## **SAFETY NOTE HANGGLIDER HARNESS**

### **TENAX DHV 03-0111-00**

**Subject** Hangglider harness Tenax DHV 03-0111-00

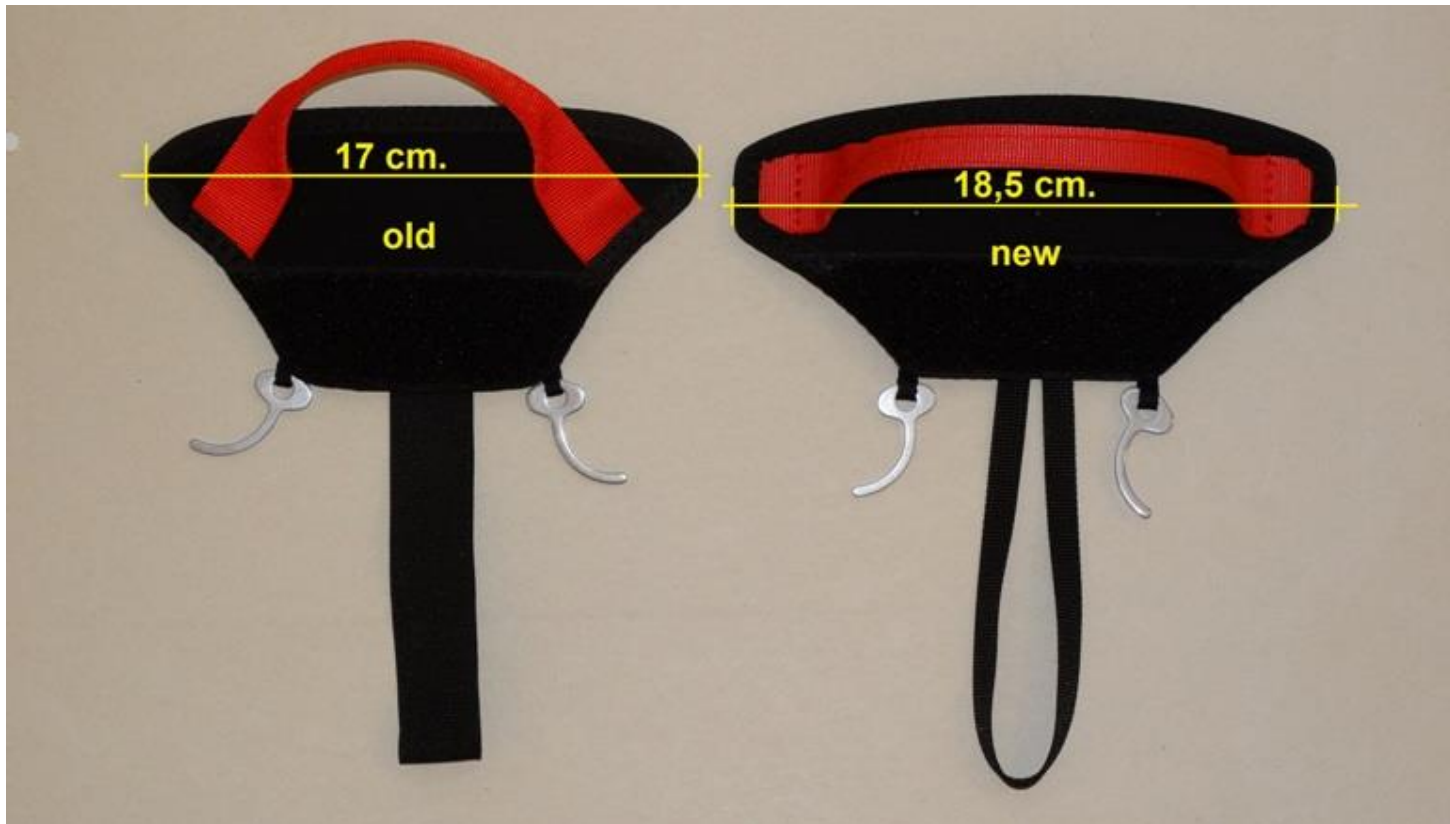
In some single cases, the dimension of the reserve parachute handle is a bit too small for fixation at the harness. The handle is then not safely fixed, because the side ends can slip out on their own accord. Woody Valley recommends all owners of the Tenax 3 harness, to check the handle and fixation at the harness. The side ends of the handle should stick safely in the fixation. If the handle is too loose in the fixation, Woody Valley recommends affected owners replacing the handle. Woody Valley offers a proper handle for free.

All Tenax 3 harnesses, which have been manufactured since the middle of 2012, are equipped with the new handle. To be sure you can compare your handle to the attached photo:
